3.2 21 Royal Crescent, Camberwell - Planning Application PP22/0045 for partial demolition, alterations and additions to a dwelling

Application no.: PP22/0045
Responsible director: Scott Walker
Authorised by: David Cowan, Manager Strategic & Statutory Planning
Report officer: Jordan Schonberg, Statutory Planner

STATUTORY PLANNING DELEGATE REPORT Urban Planning Delegated Committee

Above: Shadowing measurements within the SPOS of 19 Royal Crescent.

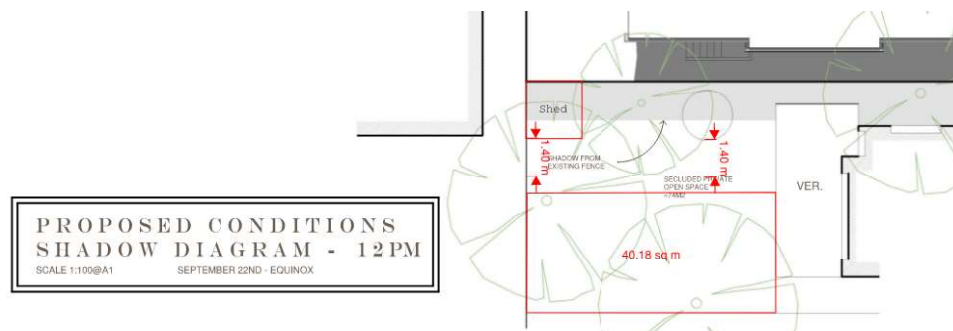
An objection has been lodged with details of an independent analysis of shadow impacts, indicating that additional shadowing of 2.53sqm will occur on the 22 September 2022. No time frame has been specified for the increase of shadow within the analysis. From an assessment of all overshadowing diagrams provided, Council is satisfied that even with an additional shadowed area of 2.53sqm, the proposal will continue to comply with the numerical requirements of standard A14 and the Overshadowing Open Space objective.

The diagram below demonstrates an area of 40sqm receiving no shadowing within the rear SPOS of 19 Royal Crescent at 12pm on September 22. This is a conservative measurement which demonstrates that even with additional shadowing of 2.53sqm and the inclusion of shadowing from the water tank and shed (not shown in the plans), the proposal complies with Standard A14.

Above: Overlooking within 9m from family room windows and rear SPOS, with raised deck circled in red

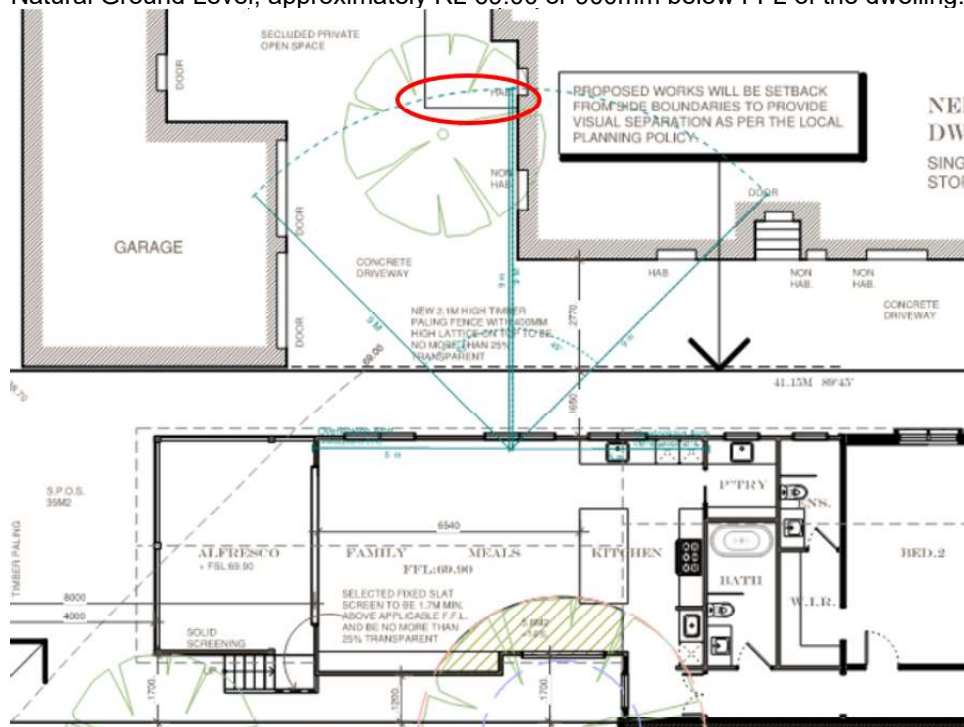
While the rear extension proposed at 21 Royal Crescent does utilise raised floor levels of the kitchen, family and meals area along with a deck at 1m above NGL, it is considered that Overlooking within the 9m arc into 23 Royal Crescent mostly falls within an area of a driveway that is not considered to be part of the SPOS of 23 Royal Crescent. As illustrated within the image below, the proposed 2.1m boundary fence

with 400mm of lattice as screening will achieve limited overlooking into the raised deck of the property to the north within a distance of 9m. No FFL is provided for the deck area and as such it has not been demonstrated that overlooking has been adequately resolved within the current proposal.

While the fence is considered to provide partial compliance to the north of the proposed addition, the neighbours to the north have also objected to the proposed new height to the boundary fence. While boundary fencing is a civil matter, the overall fence height of 2.5m will generate visual bulk impacts on this dwelling and is not supported as an appropriate screening measure. The proposed fence will need to be removed from the plans and alternative screening provided directly to the habitable room windows in question to ensure no overlooking will occur into the SPOS or habitable room windows from the proposed works.

It is noted that screening of these windows will not impact on the internal amenity of the future occupants as these rooms take benefit of other unscreened windows from different orientations providing daylight. The proposed side yard adjacent to the windows will be adequately screened by the existing side fence, being located at Natural Ground Level, approximately RL 69.00 or 900mm below FFL of the dwelling.

- c. Screening to the north facing habitable room windows at the family, kitchen and meals area and alfresco area to 1.7m from FFL in accordance with Standard A15 Overlooking.

Above: Potential oblique views into neighbouring SPOS within 9m arc from Alfresco area.

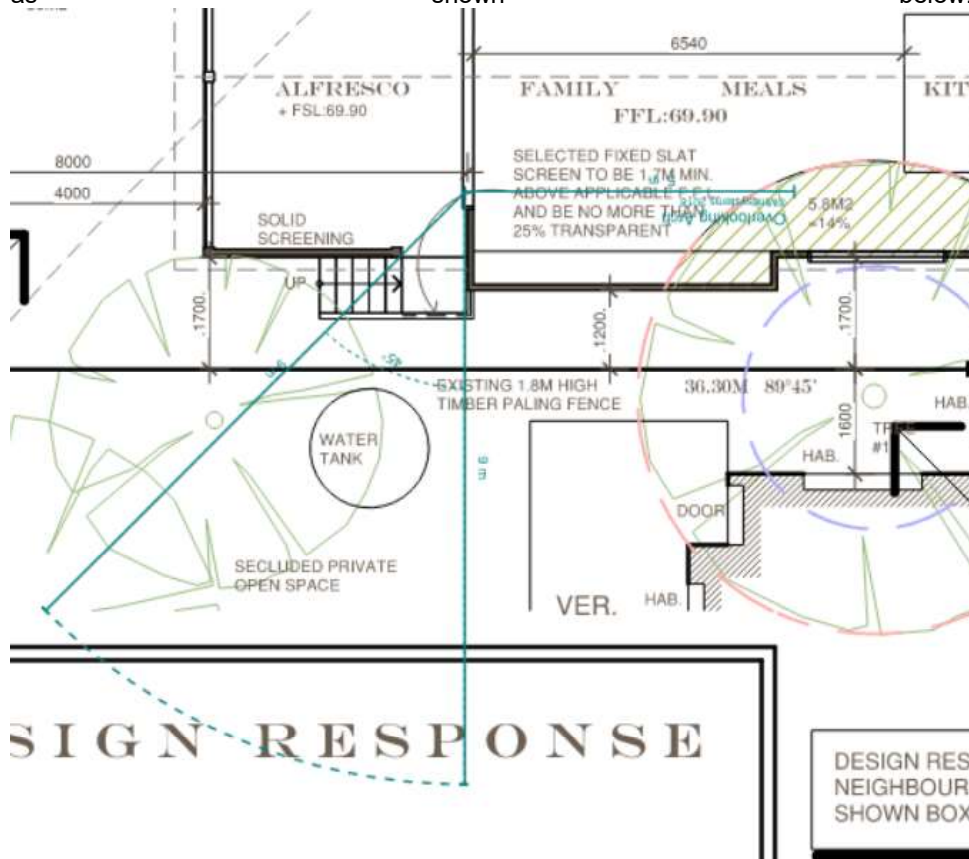
To the south of the Alfresco area, a fixed screen is proposed adjacent to the stairs to the rear garden at 21 Royal Crescent, while this screen is suitable in preventing direct views into the neighbouring SPOS at 19 Royal Crescent, it is considered the raised floor level of this area of 700mm of this alfresco area from NGL adjacent to a 1.8m fence may present potential overlooking from oblique angles within the alfresco area, as shown below.

- d. Extend the 'selected fixed slat screen' to the south at the alfresco stairs west to comply with Standard A15 Overlooking.
- e. Demonstration of compliance from the rear (west) of the alfresco area with Standard A15 Overlooking or alternative screening as required to achieve compliance.

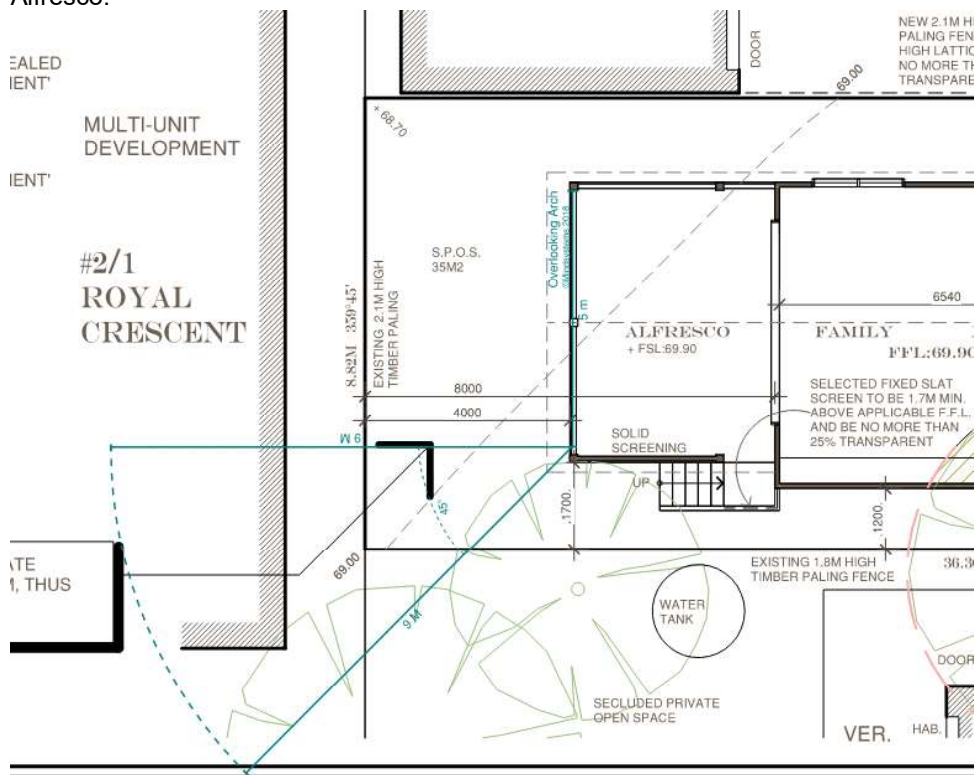
While the site to the rear of the dwelling at 2/1 Royal Crescent does fall within 9m of the rear of the Alfresco area, no habitable room windows or SPOS to this site are located adjacent to the proposed works at this site.

To confirm this matter, a condition will be placed on the permit seeking demonstration of compliance with Standard A15 or any changes as required to ensure the works comply.

The image below demonstrates the 9m overlooking arc to the rear of the proposed Alfresco.

Figure 1: Sight line diagram, Figure 2: Oblique views diagram, Figure 3: Three dimensional oblique view

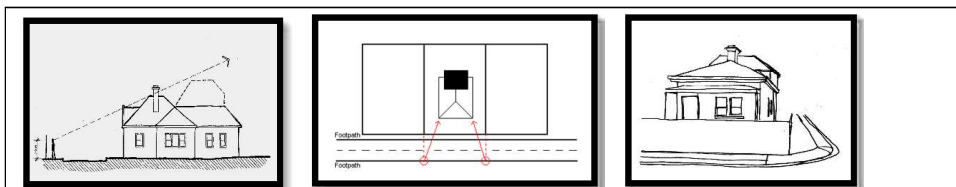
Siting and massing development to be behind and visually recessive to the heritage place as shown on Figures 1, 2 and 3.

If drawn from the northern fence line in accordance with the oblique diagram in Figure 2, the addition would have limited (if any) visibility.

Above: Shadowing measurements within the SPOS of 19 Royal Crescent.

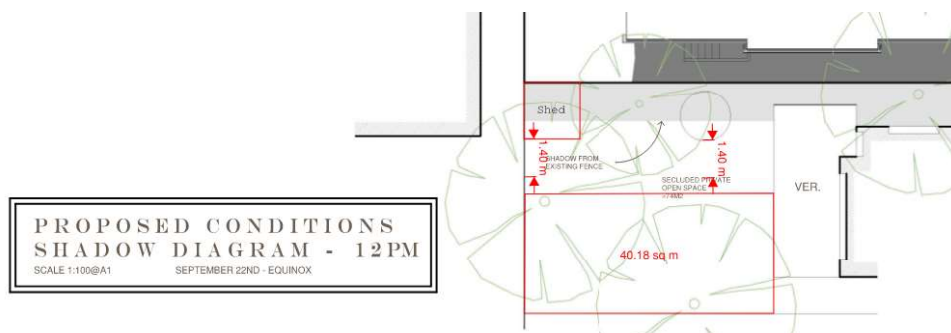
An objection has been lodged stating that additional shadowing of 2.53sqm on the 22 September 2022. No time has been specified within this objection. From an assessment of the Overshadowing diagrams provided, Council is satisfied that even with an additional shadowed area of 2.53sqm, the proposal continues to comply with the numerical requirements of standard A14 and the Overshadowing Open Space objective.

The diagram below demonstrates an area of 40sqm receiving no shadowing within the rear SPOS of 19 Royal Crescent at 12pm on September 22. This is a conservative measurement which demonstrates that even with additional shadowing of 2.53sqm and the inclusion of shadowing from the water tank and shed (not shown in the plans), the proposal complies with Standard A14.
